TECHNICAL BULLETIN
Bell Helicopter **TEXTRON**

No. 212-03-190

MODEL AFFECTED: 212

SUBJECT: LOWER NOSE DOORS P/N 212-030-217-011 & 212-030-205-001 AND SEAL REPLACEMENT

FIGURE 1 (SHEET 1 OF 4)
LOWER NOSE DOOR MODIFICATION

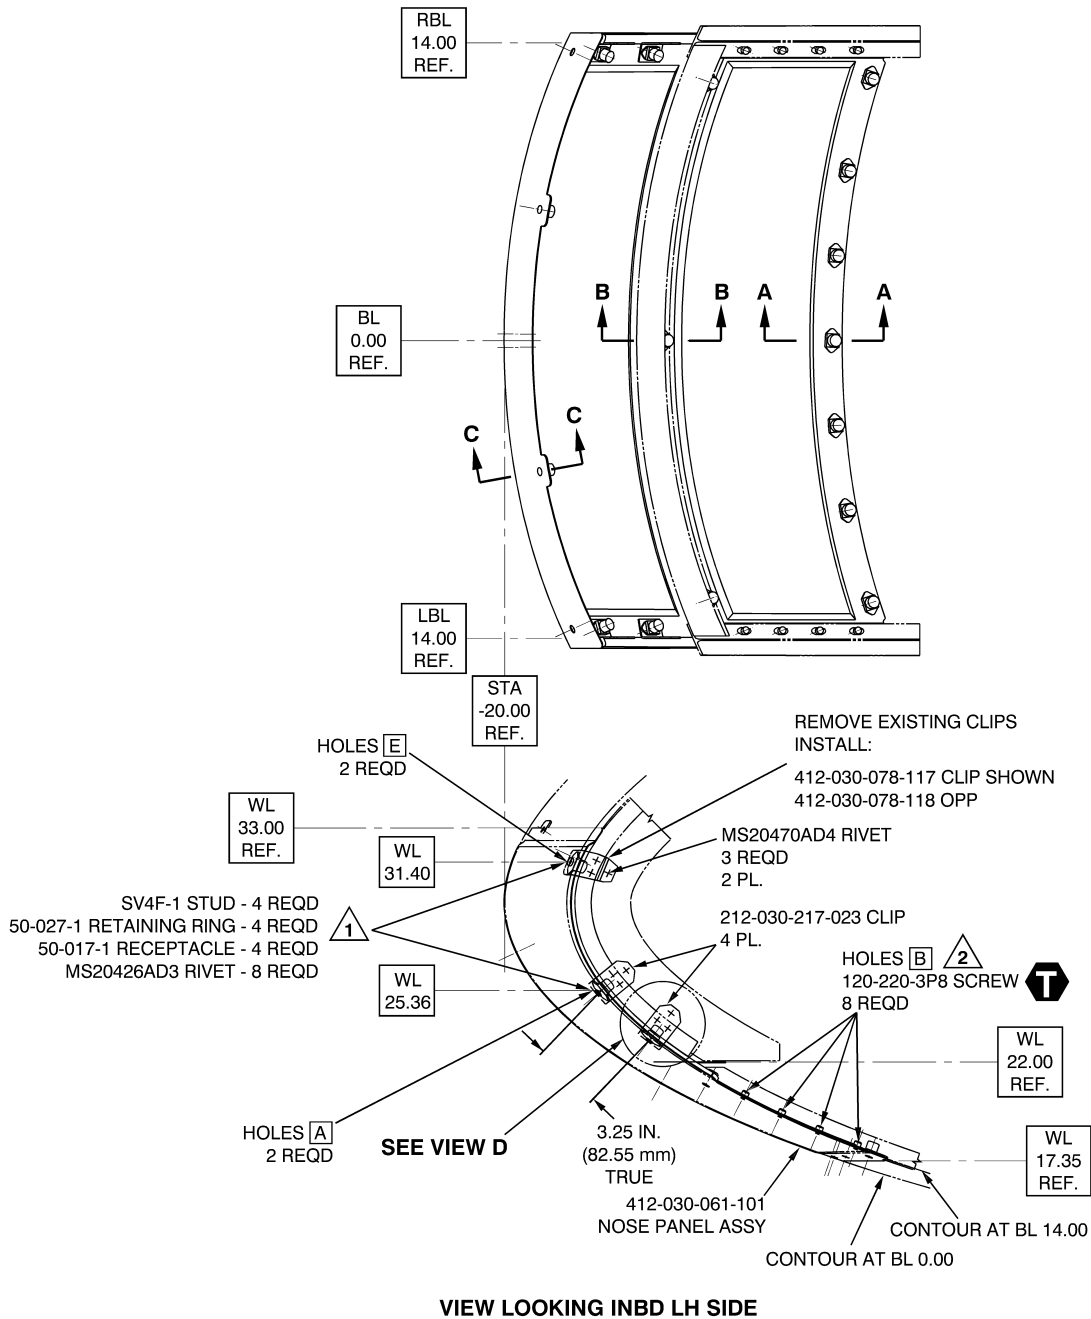
11. Position the new door P/N 412-030-061-101 and trim only enough to allow preliminary installation. **Do not trim to final dimensions at this time.**
12. Transfer holes A & B from structure. Reinstall previously retained receptacles and applicable hardware (see Figure 1, Sheet 1).
13. Using a locally fabricated template made from a sheet of clear plastic (or equivalent method), transfer holes C to nose door and install applicable hardware (see Figure 1, Sheet 2, Section B-B).
14. Position new clips P/N 212-030-217-023 inside nose door at approximately 3.25 inches (true) down from holes A, picking up existing rivet locations on frames at RBL and LBL 14 with a minimum edge distance of twice the rivet diameter. (See Figure 1, Sheet 1) Drill two pilot holes with a #40 approximately 1 inch from the edge to locate the center of the receptacle holes.

15. Install clips P/N 212-030-217-023 (see Figure 1, Sheet 3, View D), open holes D to final size and install applicable hardware.
16. Position clips P/N 412-030-078-117 and -118 to pick up the rivet holes left open by the previously removed clips at WL 31.4 with a minimum edge distance of twice the rivet diameter. Install clips and open holes E to final size. Install previously retained receptacles and applicable hardware. (See Figure 1, Sheet 1)

FIGURE 1 (SHEET 2 OF 4)
LOWER NOSE DOOR MODIFICATION

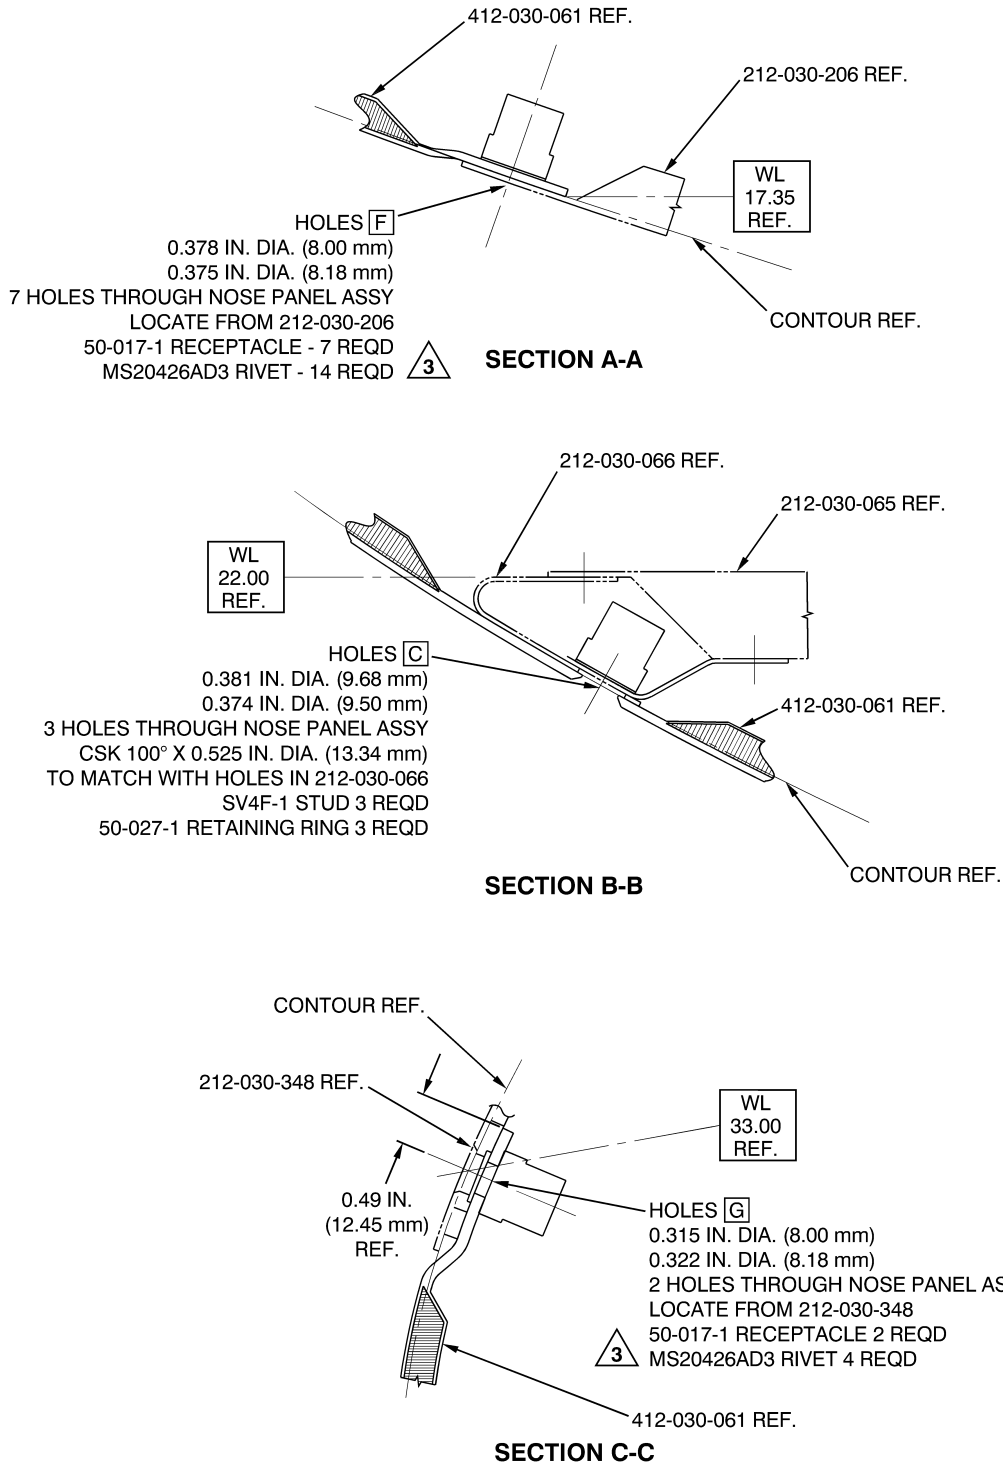
17. Transfer holes F from panel (see Figure 1, Sheet 2, Section A-A) to the door assy. Open holes to final size and install applicable hardware.
18. Close upper nose door, transfer holes G, open holes to final dimension and install applicable hardware (see Figure 1, Sheet 2, Section C-C).

FIGURE 1 (SHEET 3 OF 4)
LOWER NOSE DOOR MODIFICATION

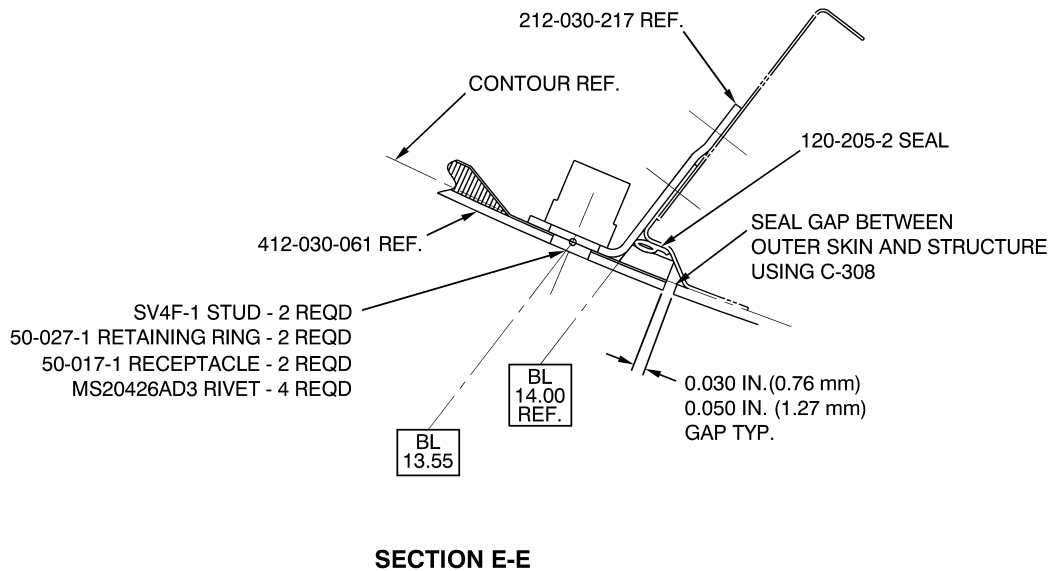
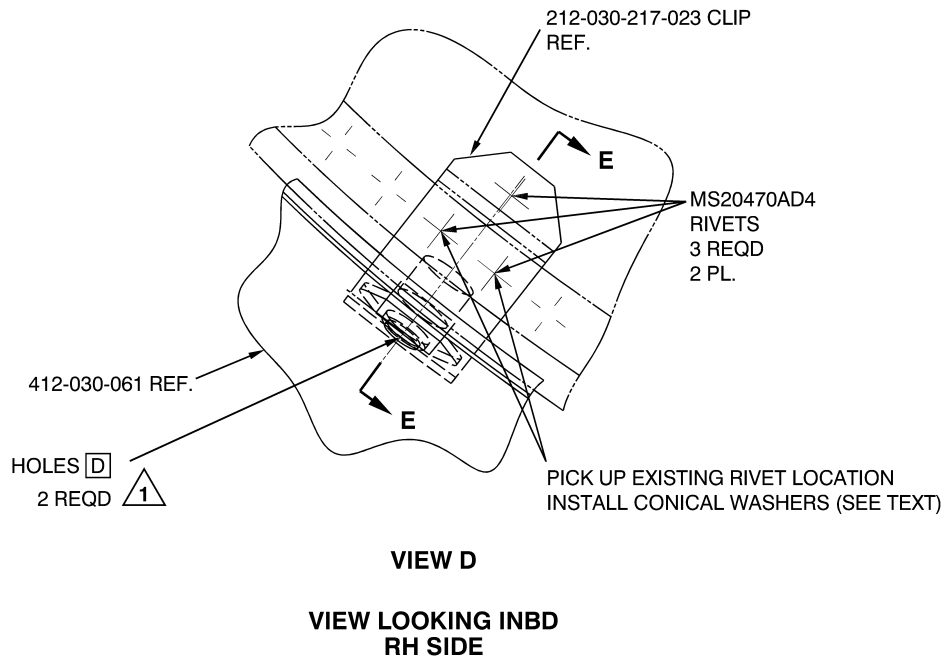
19. Once all fasteners are secured, mark for and trim the nose door to obtain a gap of 0.030 to 0.050-inch around the lower nose door. See Figure 1, Sheet 3, Section E-E.

2. Using a plastic scraper, remove the seal from the nose structure around the periphery of the opening of the upper and lower nose doors.
3. Install seal P/N 120-205-2 on the nose structure around the upper and lower nose door opening using adhesive (C-300). Refer to Figure 1, Sheet 3.
4. Apply a light bead of sealant (C-308) around the nose door opening to seal the gap between the outer skin, the structure and the seal. Refer to Figure 1, Sheet 3. Allow sealant to cure for 24 hours.
5. Install upper nose door. Reinstall lower nose door (or refer to Part A, if replacing the door).
6. Close and latch nose doors, and verify for watertightness. Correct, if required.
7. Refinish as required.
8. Make helicopter ready for flight.
9. Make an entry in helicopter historical records indicating compliance with this technical bulletin.

FIGURE 2
SEAL INSTALLATION

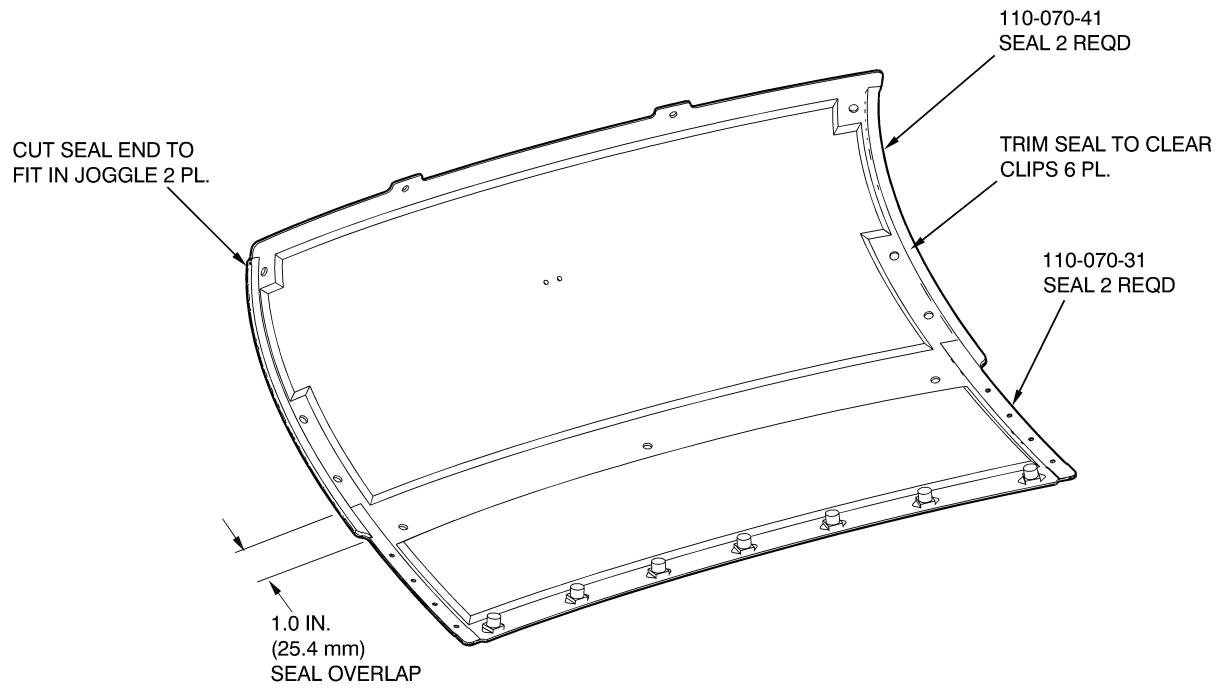
20. Install the door seals P/N 110-070-31 & 41 along left and right sides of the door, using adhesive (C-300), as shown on Figure 2. Trim seals to clear clips (6 places), if required.
